MEMORANDUM

REVIEW TYPE: Preliminary Plan of Subdivision

PROJECT NAME: Manor Park-Section I

CASE #:

15220 GEORGIA AVENUE
 PARCEL 286
 PROPOSED LOTS 32 & 33
 MANOR PARK, SECTION 1
 PRELIMINARY PLAN
 M-NCP&PC FILE NO. 1-20090170

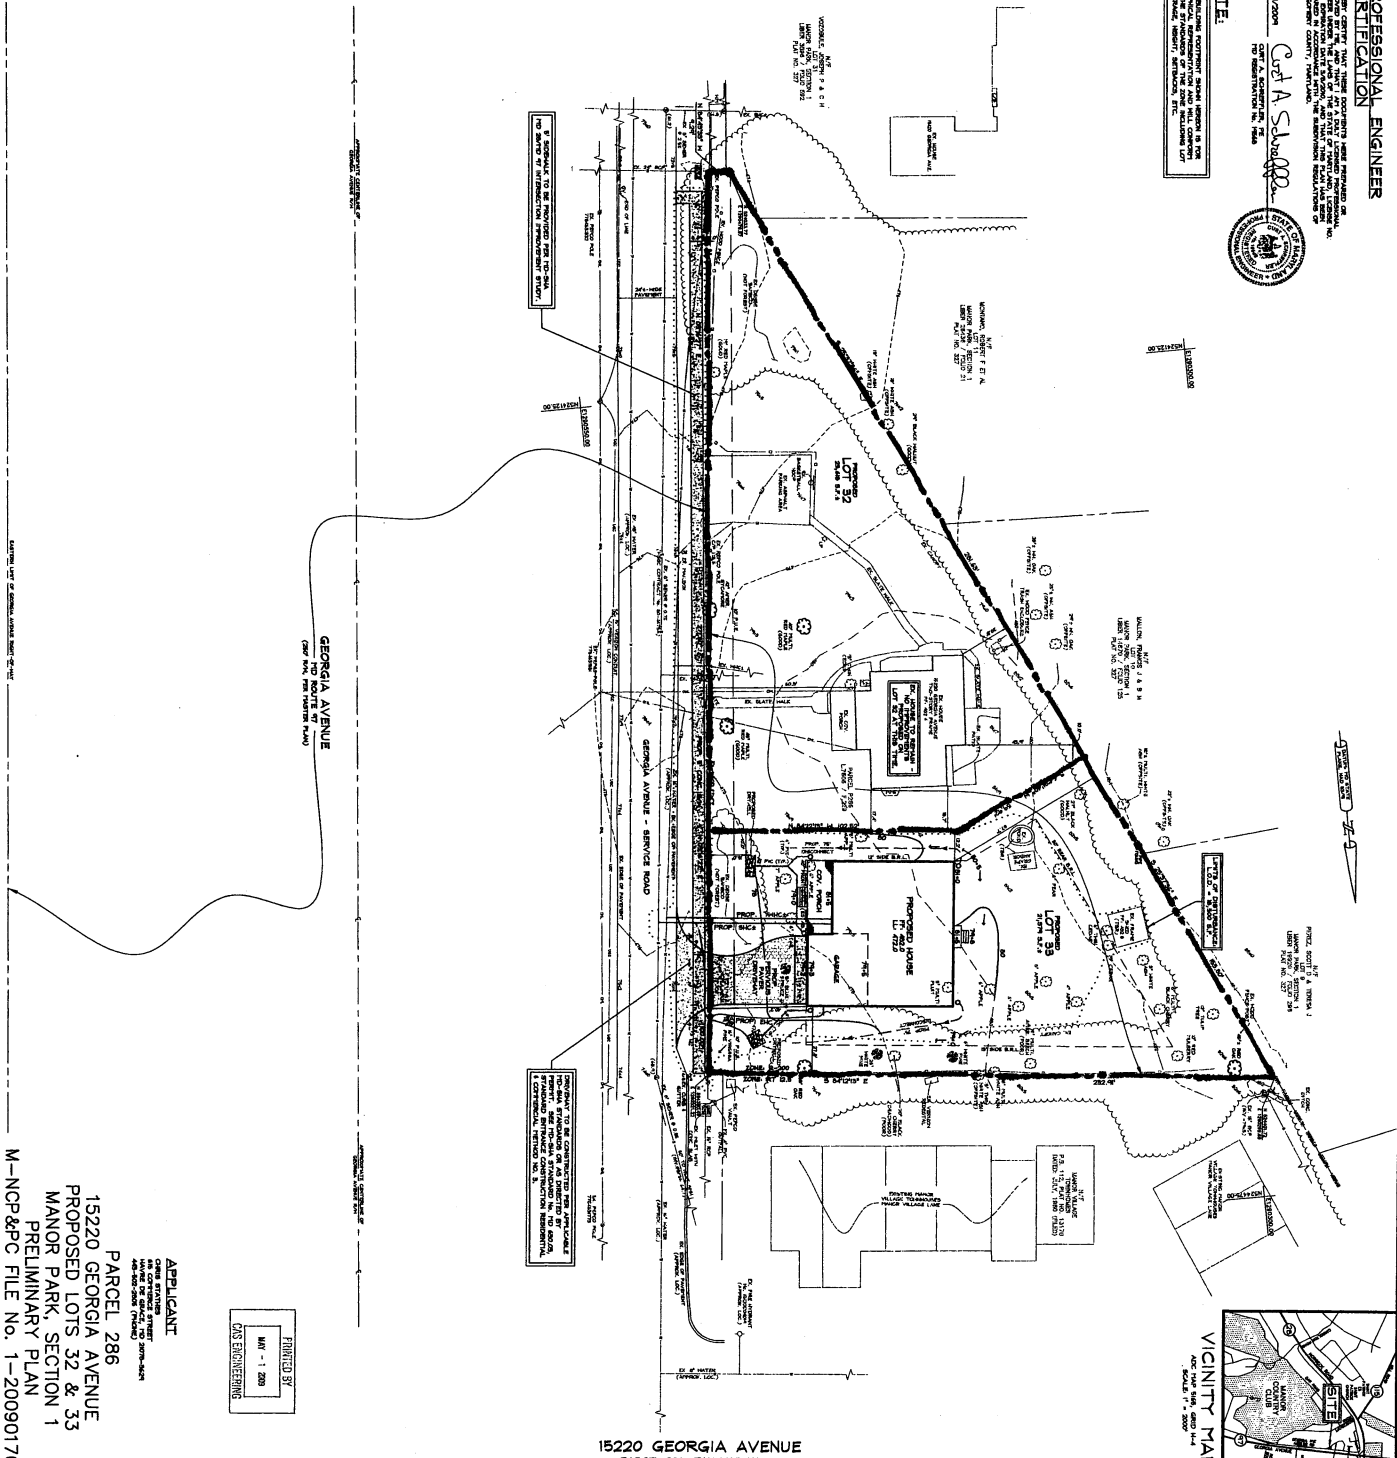
- The proposed driveway should provide a minimum entrance width of 20ft with 20ft. minimum radii.
- Reference the appropriate MDSHA Standard for the residential entrance apron.
- A permit will be required from SHA's District 3 Utilities office to construct the proposed driveway. Please contact Mr. Augie Rebish, ADE-Utilities, at 301-513-7350.

**Alternative 7 (Enhanced)
Relocated MD 28
Depressed Under MD 97**

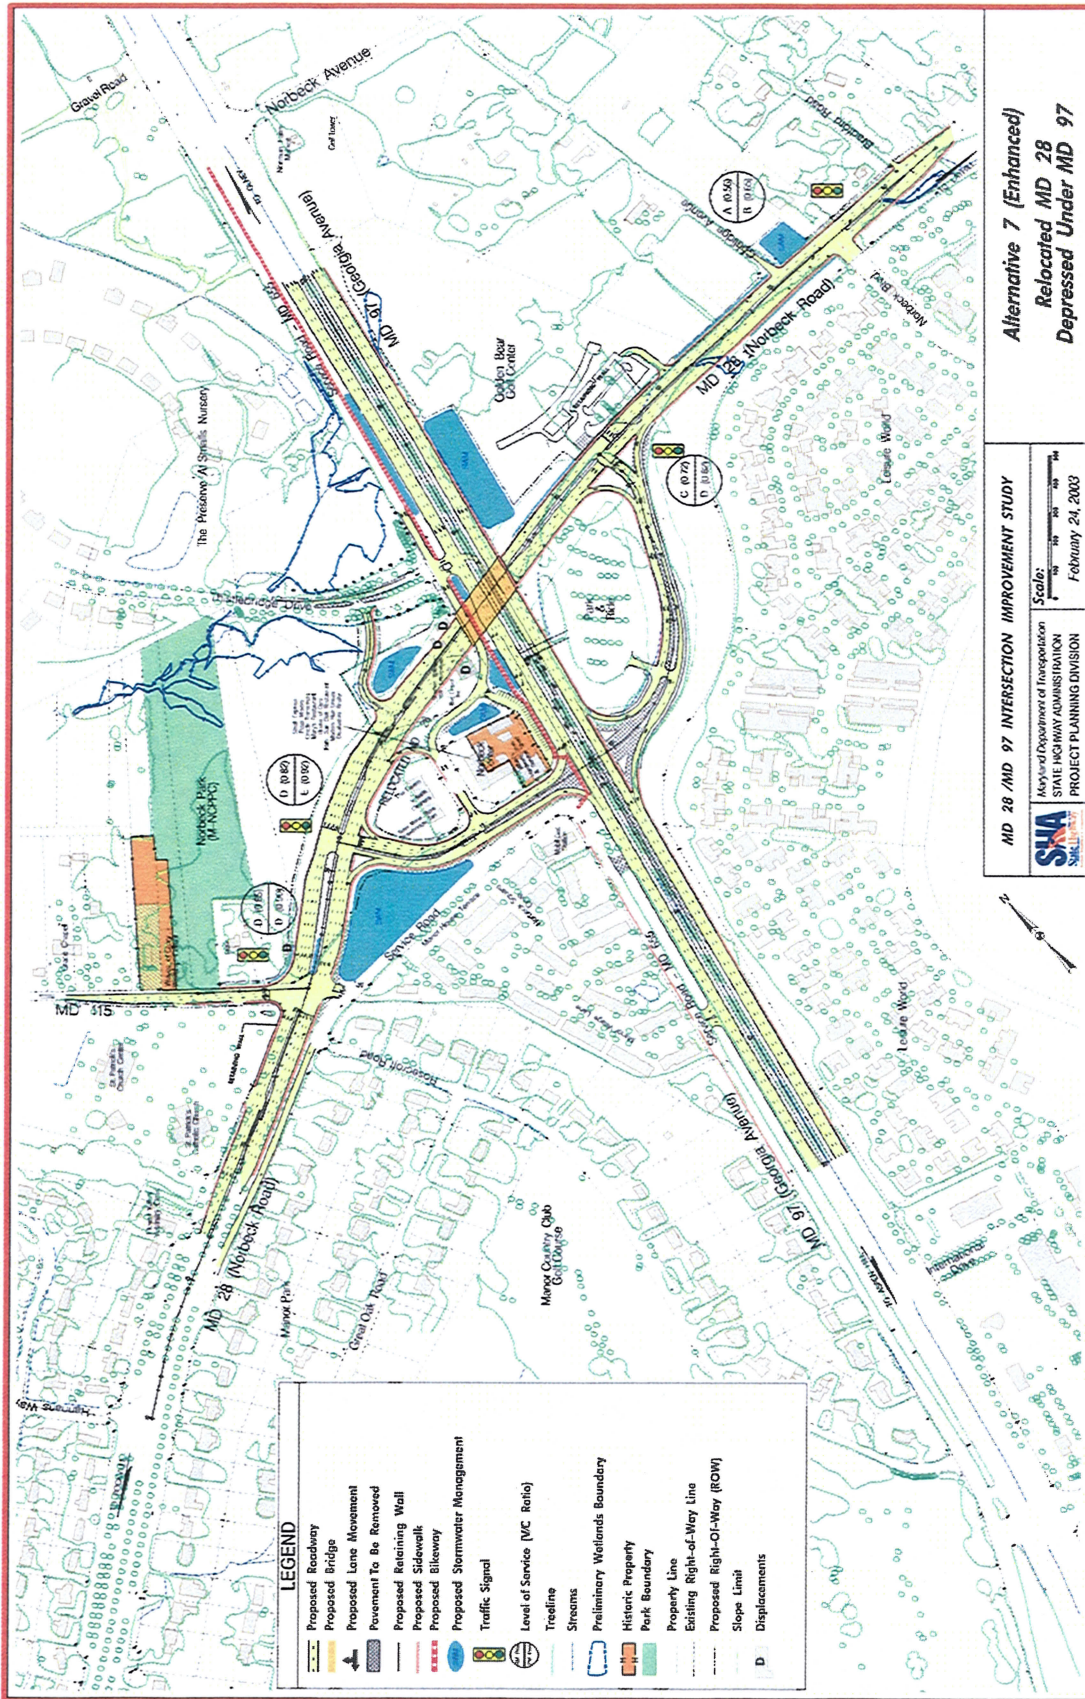
Property's frontage but future construction of a sidewalk is included in the MDSHA Norbeck Road (MD 28) and Georgia Avenue (MD 97) Interchange design. The Applicant is, therefore, required to construct a 5 foot-wide sidewalk along the entirety of the Property frontage in anticipation of the funding of this project and installation of the remaining improvements in the future. Proposed vehicle and pedestrian access for the subdivision will be safe and adequate with the proposed public and private improvements.

- c. The certification and builder acceptance letter must be provided to MNCPPC Environmental Planning staff before building permits are approved.
- 4) The Applicant must construct a 5 foot-wide sidewalk within the right-of-way along the Georgia Avenue service road property frontage, off-set two feet from the property boundary.
